Sunset Neighborhood Park Master Plan

Open House Meeting #3 Agenda

Date: September 23, 2014

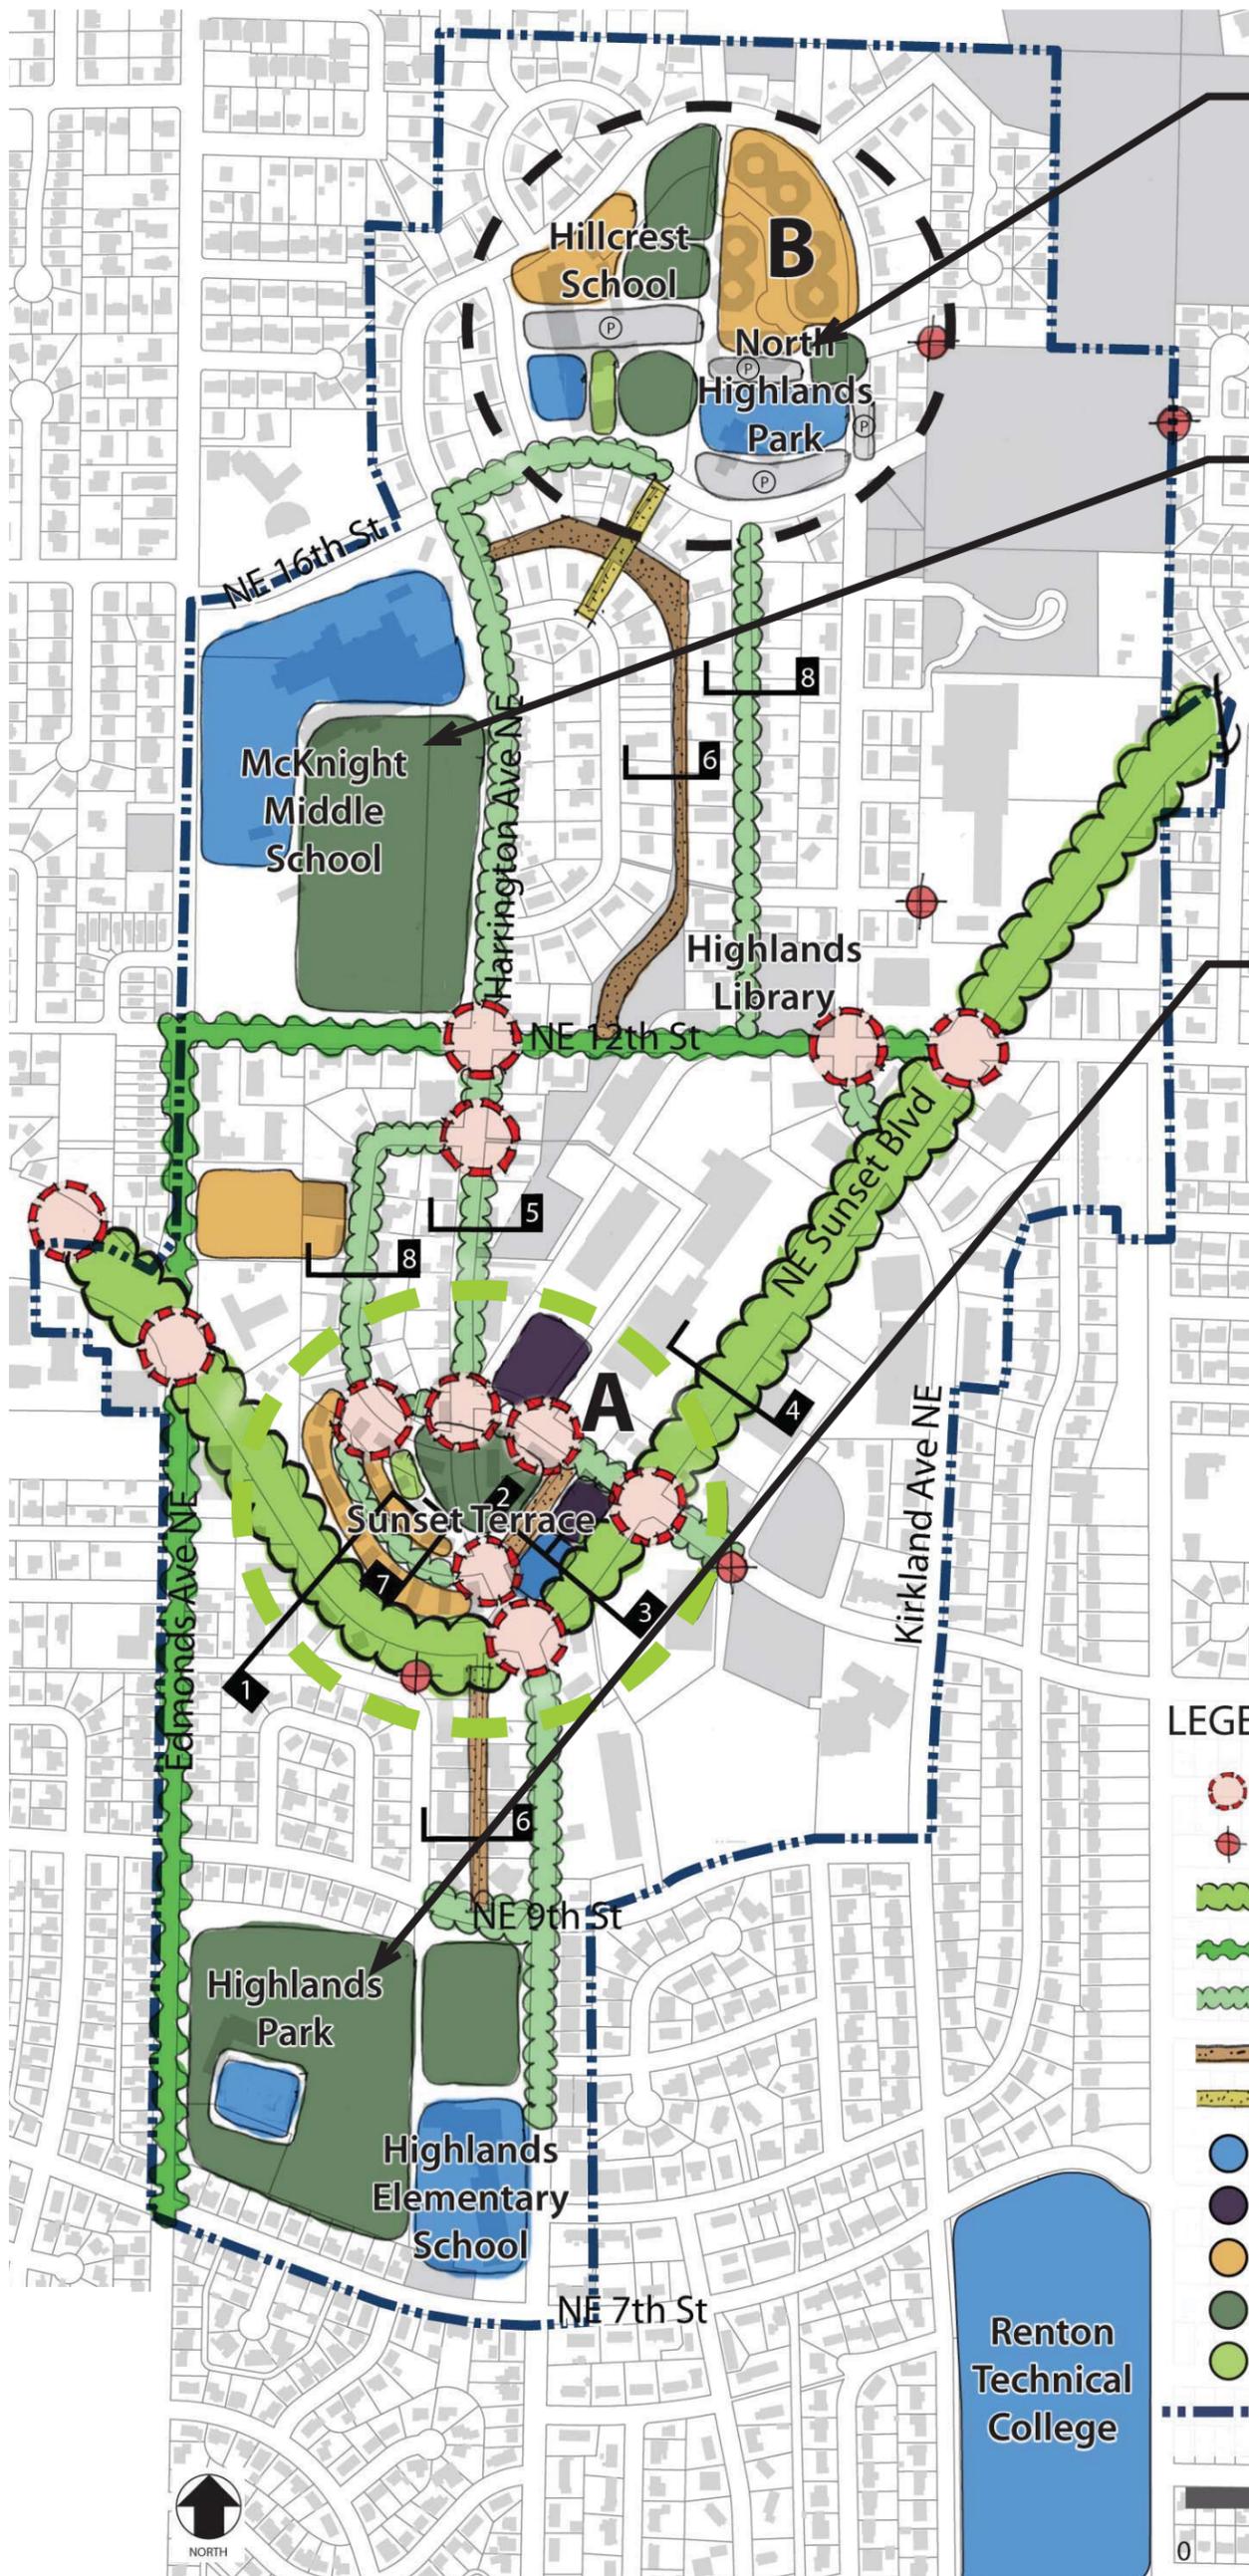
- 1) **Question:** Is the lighting for the walls and seating going to be overhead lights or recessed lighting?
Response: The lighting incorporated in the walls and seating is intended to be recessed lighting.

- 2) **Comment:** Likes the modern restroom photo example.
Response: The restroom building will be architecturally modern.
- 3) **Comment:** Likes that no hills (for kids to roll on) run directly into the street.

- 4) **Comment:** Likes overhead structures that provide shade and cover during rainy season.
- 5) **Question:** What plants will be in the rain gardens?

- 12) **Comment:** Likes the water feature.
- 13) **Comment:** The park should include a climbing feature.

- 14) Comment:** Likes the circular bench in the interpretive area, because it could provide an area for reading.
- 15) Question:** Is seating provided under the pergolas?

- 20) Question:** Could the pergolas provide more shelter from the rain and provide a continuous cover above?
Response: This can be considered in further development of the design.

- 21) Comment:** Mileage markers should be included on the loop trail.
- 22) Comment:** The play area should include swings.
- 23) Comment:** Likes the Port of Olympia water feature.

Response: The plant palette will be native and drought tolerant, with a few accent plants and boulders; more gardenesque.
- 6) **Comment:** The rain garden should look aesthetically appealing.

Response: Seating is provided under the pergolas. There is a seatwall under the pergola at the entrance near the library. There are benches under the pergolas in the main open space area.
